E.1.b.b1475 Fort Street: Update on Development Permit with Variances Application No. 00120 (Rockland)

To:	Committee of the Whole	**Date:**	November 4, 2021
From:	Karen Hoese, Director, Sustainable Planning and Community Development		
Subject:	**Update on Development Permit with Variances Application No. 00120 for 1475 Fort Street**

Development Permit with Variance #00120

Sheet Name
FLOOR PLANS

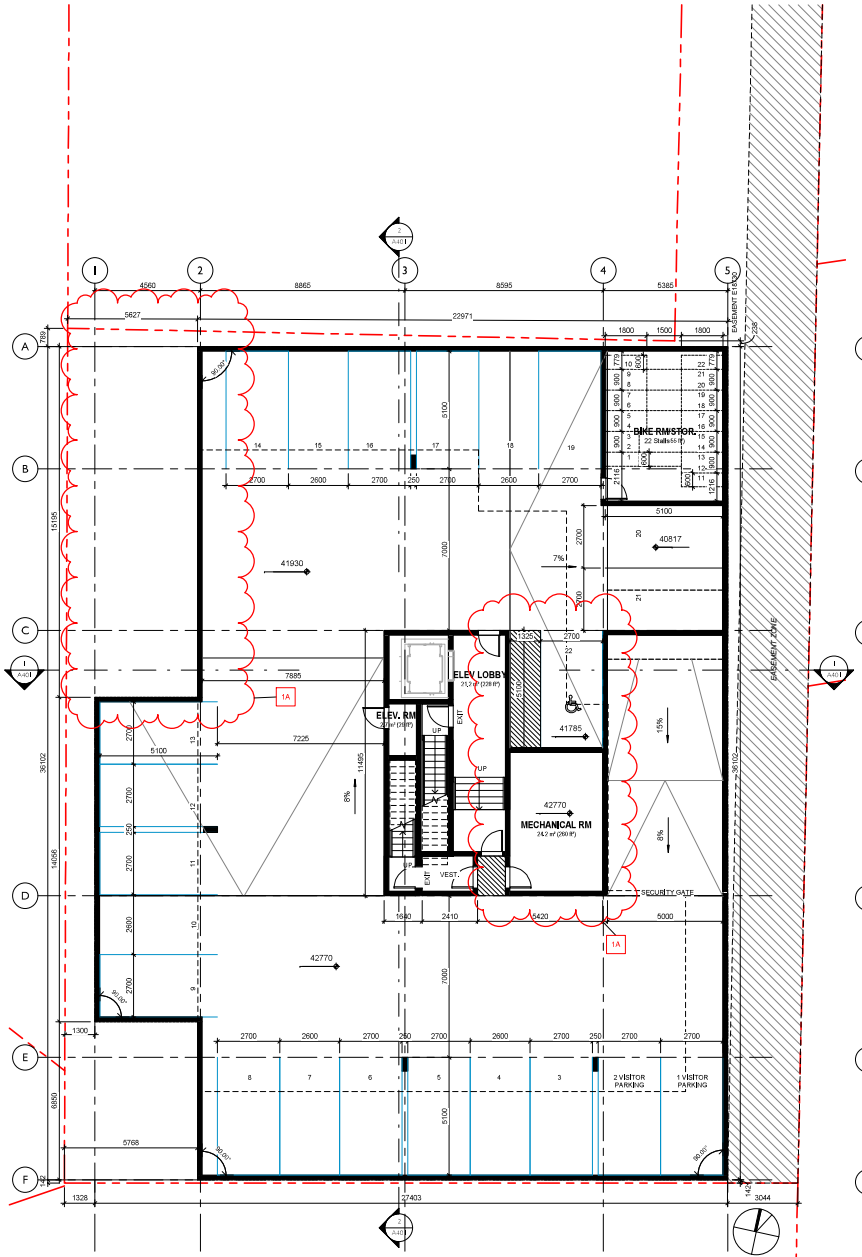
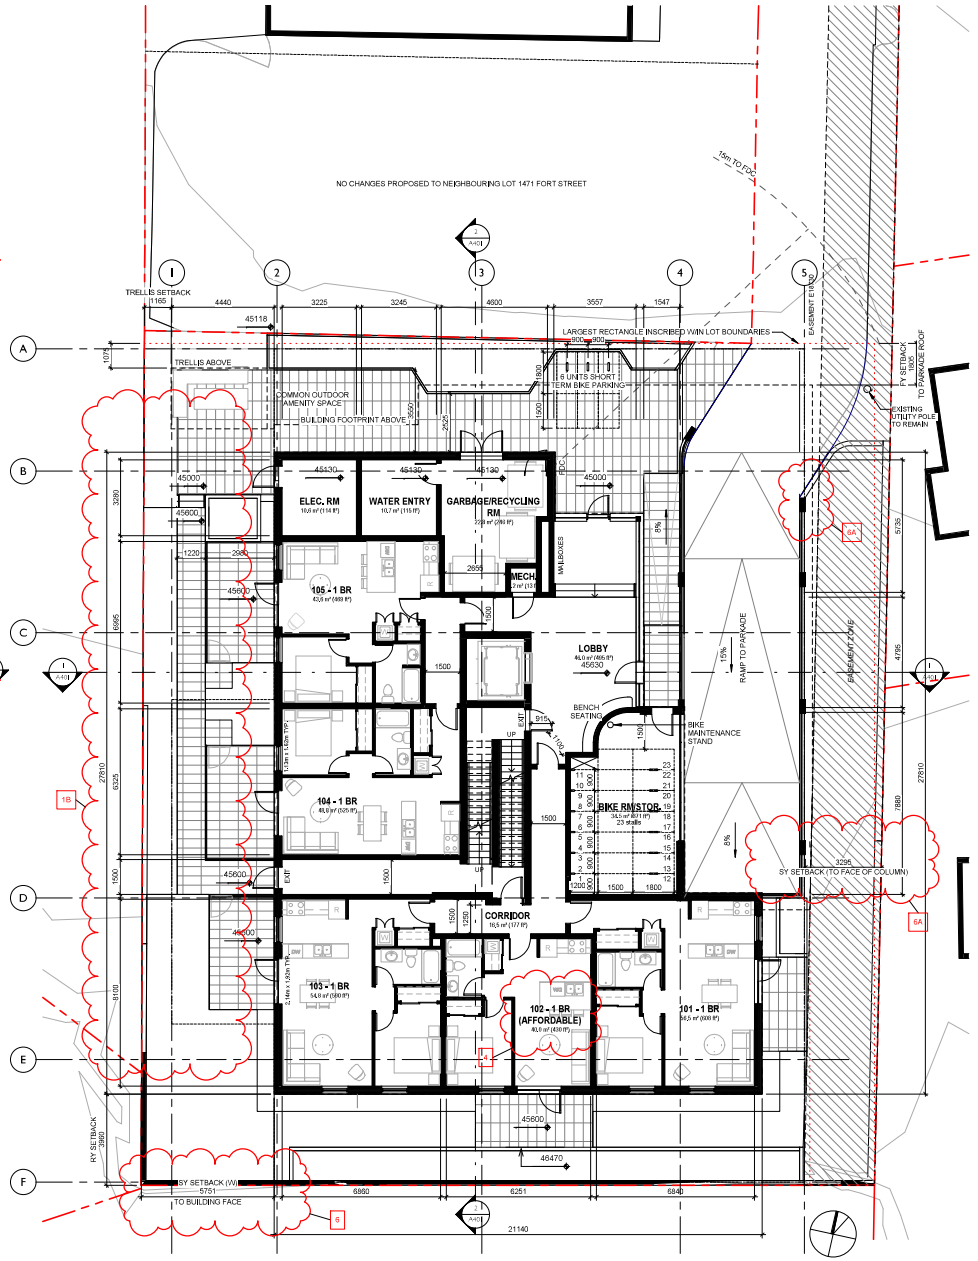
In response to Council's direction, the footprint of the underground parking structure has been reduced along the west property line to preserve non-bylaw protected trees #990, #991, #992, #993 and #NT5 on the subject lot. Pulling back the parking structure not only allows for retention of the existing trees, it also preserves an area with greater soil depth, unobstructed by structure, which can accommodate new trees in the future.

Sheet Name
ELEVATIONS

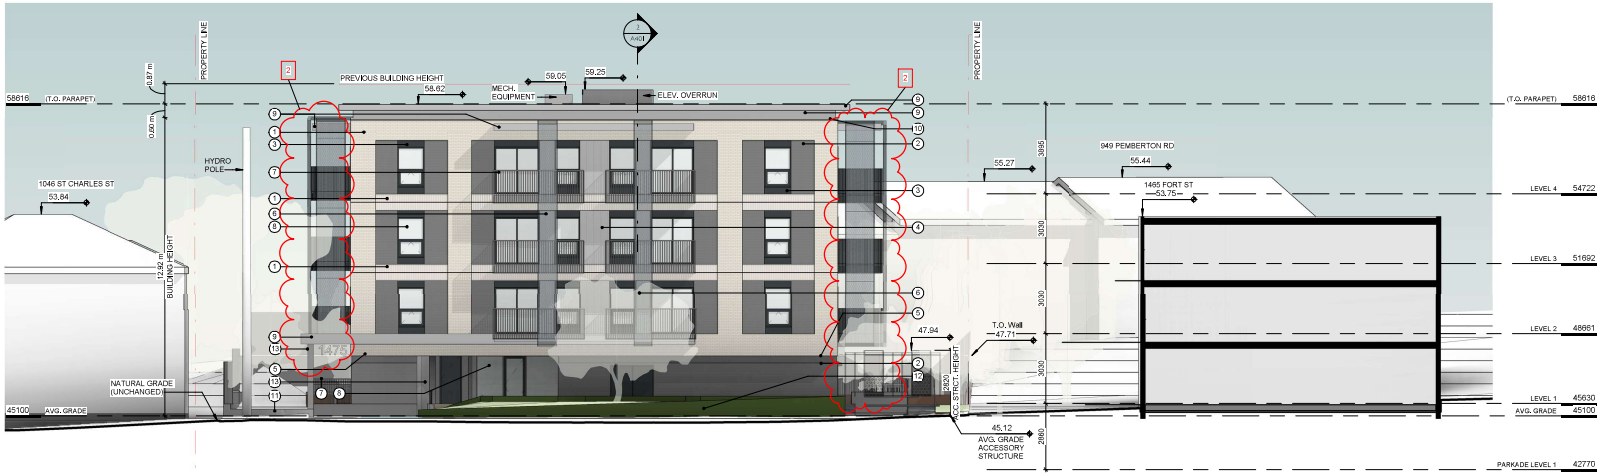
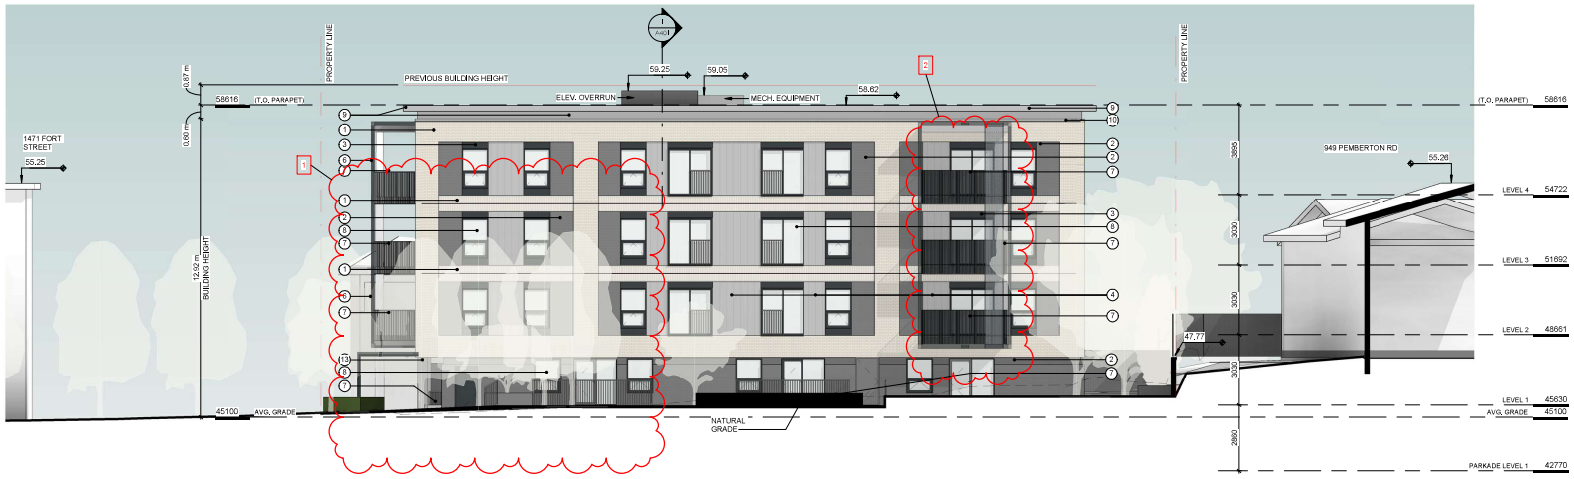
Aside from a minor increase in the setback to the east balconies (3.05m to 3.29m), the proposed setbacks have not changed on the revised plans. However, in addition to retaining existing trees along the west property line, the applicant has made the following changes to address privacy concerns:

- balconies on the east and west elevations have been shifted further north and the picket railings have been thickened and rotated forty-five degrees to limit sightlines and improve privacy for residents and neighbours
- picket railings on the south facing Juliet balconies have also been modified to reduce sightlines and have been extended to cover the adjacent fixed window
- widening of the landscape planter along the south property line to accommodate a more robust Yew hedge, which will in turn provide visual screening between properties.
